PLANNING APPLICATION SUMMARY TABLE:

Response to SEPA Screening Response

Planning Application: Table 1 Responses to SEPA Screening Response

**Eisgein Construction
Berthing Facility
Planning Application**

Photo 22: Burn 12

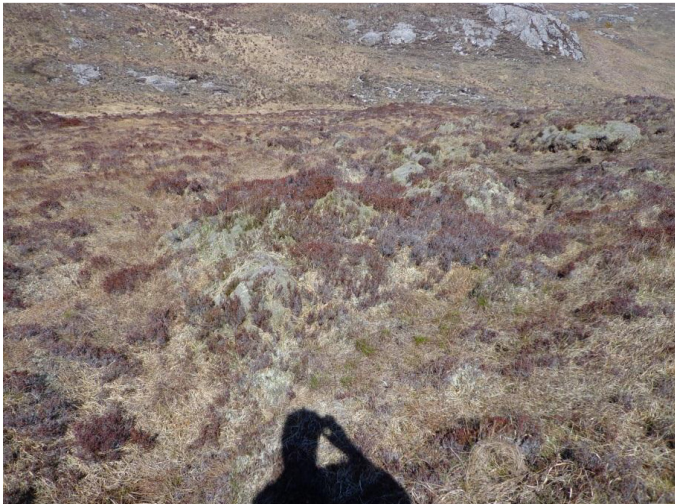
Crossing Number	Watercourse Name/Type and Summary Description	NGR		Photograph Reference (both directions)	Likely Engineering Activities in Near Vicinity	Potential Impacts	Mitigation (to be detailed in the Construction Environmental Management Document - CEMD)
		Eastings	Northings				
13	Burn leading from col south of Beinn Gearraidh Raistail	31633	11469	24, 25	<ul style="list-style-type: none"> • Excavation of soil and underlying rock substrata • Construction of access track • Physical blocking up of grip 	Localised flooding	<ul style="list-style-type: none"> • Installation of 250mm pipe to maintain drainage; or • Re-route ditch to maintain flow of water
